Disabling regenerative braking on the DNO series

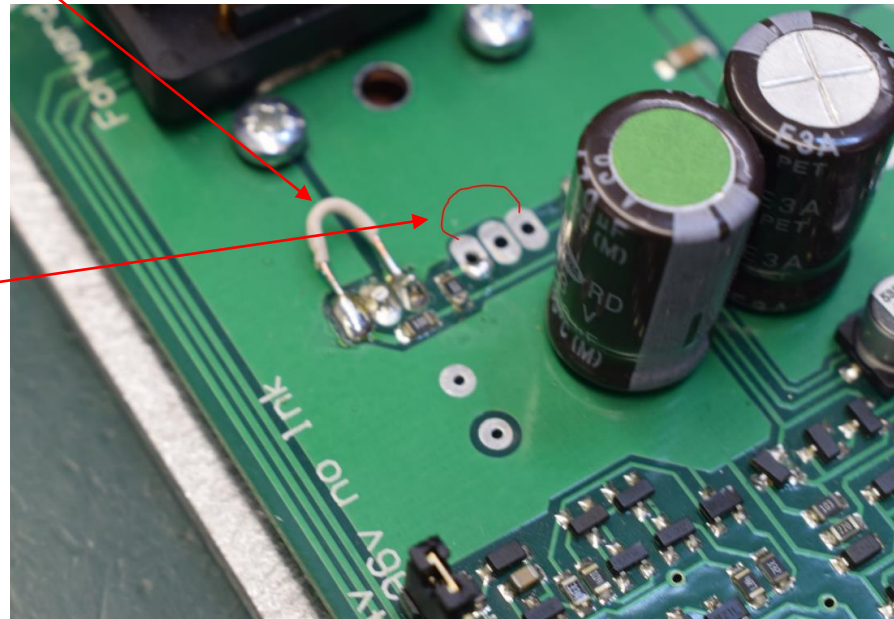
1. Identify and remove this 100 ohm resistor.

2. Fit a shorting link between the gate and source legs of the highside mosfet [s].

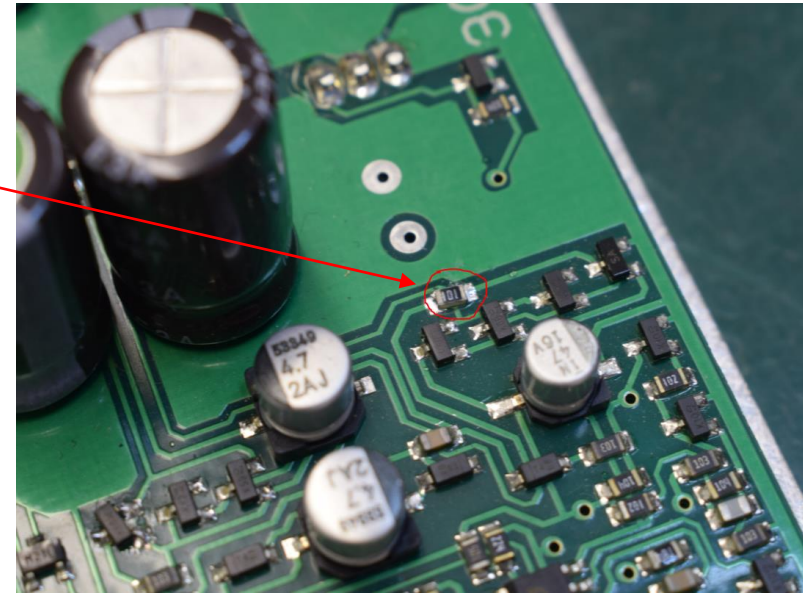
3. For the DNO 10 fit a shorting link across the mosfet that is here as well.

Note: Avoid setting the deceleration time to low values after this modification. After the DNOs internal ramp has reached zero, the direction relays will drop out and put a direct short across the motor which will cause a sudden stop.
